Access Compliance Report

Public Rights-of-Way

(Curb Ramps)

Intersection ID: 29459	Main Street: N_ALEXANDER_ST	Cross Street: GARDEN_DISTRICT_DR	Location: S
ADA ID: 3A7CAA9EB7D4	Ramp Type: PerpDiag	Initial Pass/Fail: Fail	Overall Compliance: No
Codes/Mitigation Info/Possible Solution		Field Measurements/Component Compliance	
Severity Score: 10

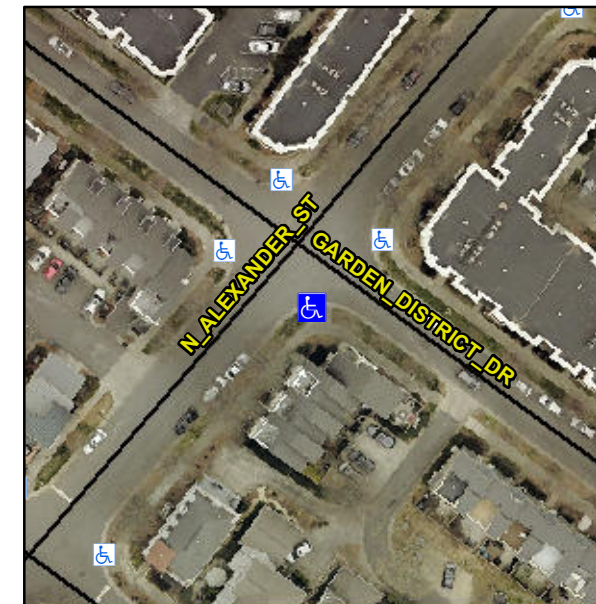
Not Found, R304.5.1, R304.5.3

Compliance	Description	Data	Compliance	Description	Data
N/A	Ramp Length (in)	73.0	Yes	Ramp Slope (%)	7.1
No	Ramp Width (in)	43.5	No	Ramp XSlope (%)	4.0
N/A	Flare Type LT	N/A	N/A	Flare Type RT	N/A
N/A	Flare Slope LT (%)	N/A	N/A	Flare Slope RT (%)	N/A
N/A	Flare Traversable LT?	N/A	N/A	Flare Traversable RT?	N/A
N/A	Landing Length (in)	N/A	N/A	DWS Provided?	N/A
N/A	Landing Width (in)	N/A	N/A	DWS Contrast?	N/A
N/A	Landing Slope (%)	N/A	N/A	DWS Length (in)	N/A
N/A	Landing X Slope (%)	N/A	N/A	DWS Full Width?	N/A
N/A	Landing Curb? (Y/N)	N/A	N/A	DWS Offset (in)	N/A
N/A	Shared Landing?	N/A			
N/A	Gutter Ponding?	N/A	N/A	Gutter Slope (%)	N/A
N/A	Gutter Lip Ht (in)	N/A	N/A	Gutter X Slope (%)	N/A
N/A	Painted X Walk1?	No	N/A	Painted X Walk2?	No
	X Walk 1 Direction	To NE		X Walk 2 Direction	To NW
N/A	X Walk 1 Width (in)	N/A	N/A	X Walk 2 Width (in)	N/A
	X Walk 1 Slope (%)	2.6		X Walk 2 Slope (%)	1.6
	X Walk 1 X Slope (%)	1.5		X Walk 2 X Slope (%)	3.5

Remove & Replace Curb Ramp With Two New Directional Ramps or Equivalent.
